UNITED STATES
NUCLEAR REGULATORY COMMISSION
WASHINGTON, D. C. 20555

SUBJECT: ISSUANCE OF AMENDMENTS (TAC NOS. M83068 AND M83069) (TS 92-01)

AMENDMENT NO.167 FOR SEQUOYAH UNIT NO. 1 - DOCKET NO. 50-327 and
AMENDMENT NO.157 FOR SEQUOYAH UNIT NO. 2 - DOCKET NO. 50-328
DATED: April 28, 1993

SEQUOYAH NUCLEAR PLANT, UNIT 1

FIGURE 5.6-2 EXAMPLE OF CHECKERBOARD SPENT FUEL STORAGE ARRAY

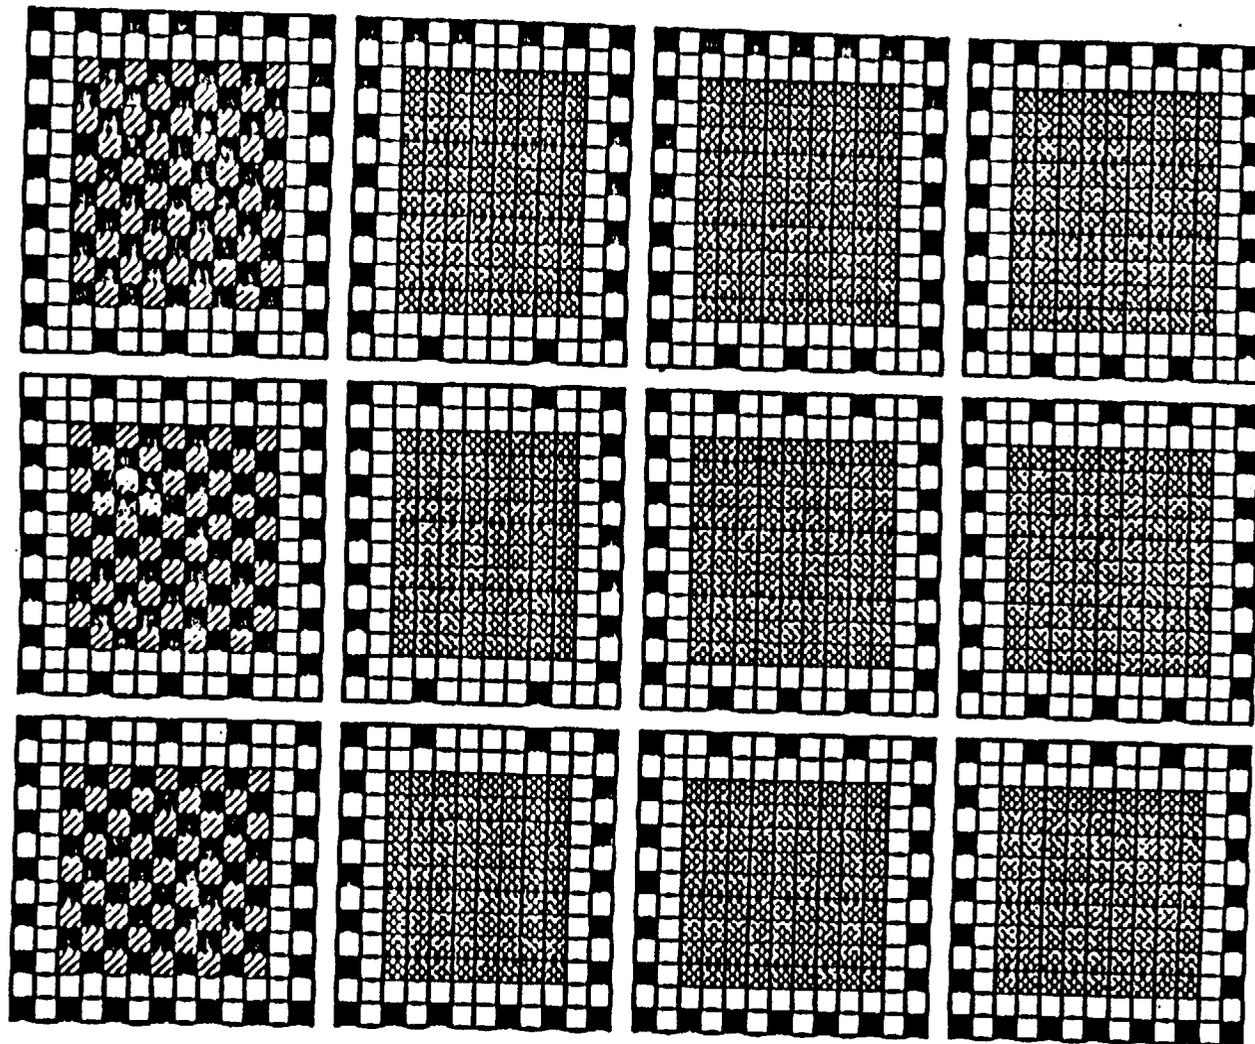
4. A checkerboard pattern of fresh fuel and empty cells may be used throughout any storage module, or internal to any storage module in lieu of Region 3 fuel as shown in Figure 5.6-2.

Figure 5.6-1 shows a typical arrangement of regions. Figure 5.6-2 illustrates internal module checkerboarding of fresh fuel with empty cells in a portion of the fuel pool. Figure 5.6-3 illustrates the two burnup-enrichment equations (5.6.1.1.c.2 and 5.6.1.1.c.3) in graphical form.

FIGURE 5.6-3

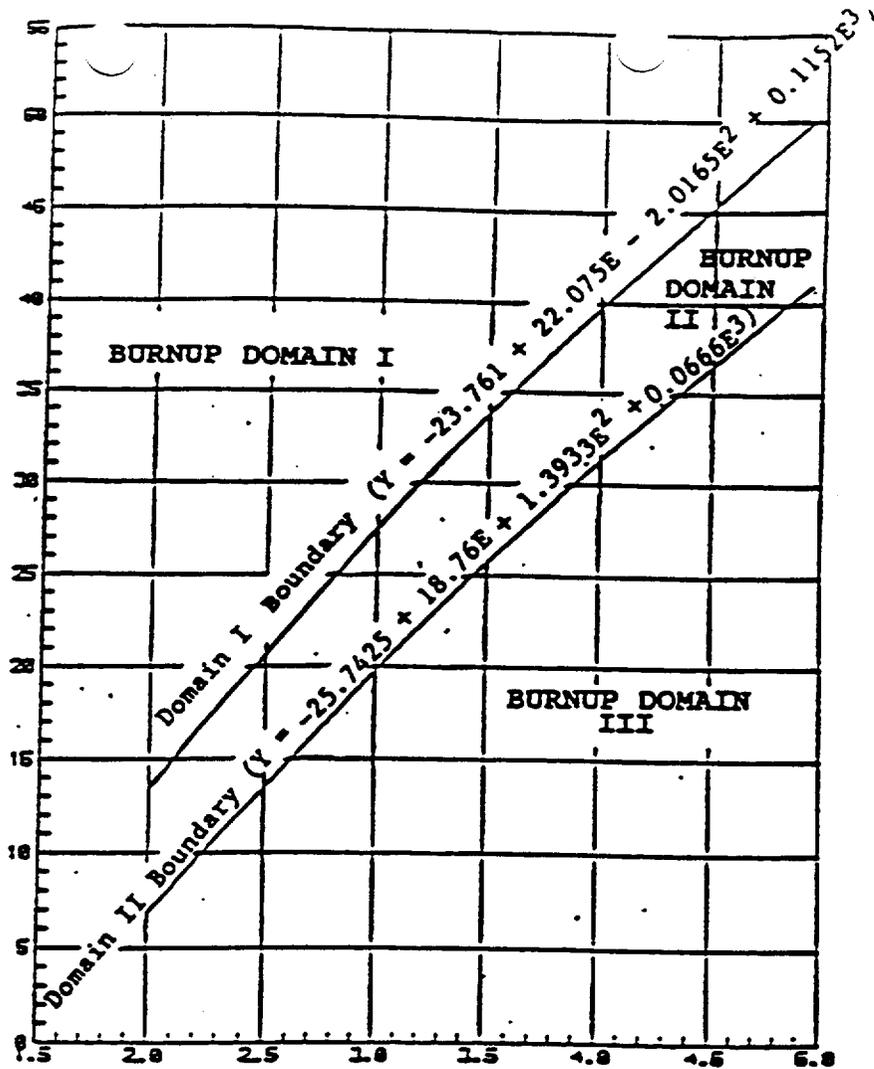
SFP with accompanying definitions and an explanation of where fuel assemblies would be stored according to initial fuel enrichment and burnup parameters. Figure 6.5-1 would be added to illustrate a typical arrangement of fuel regions. Figure 5.6-2 would be added to illustrate internal module checkerboarding of fresh fuel with empty cells. Figure 5.6-3 would be added to illustrate graphically the two fuel burnup versus enrichment equations.
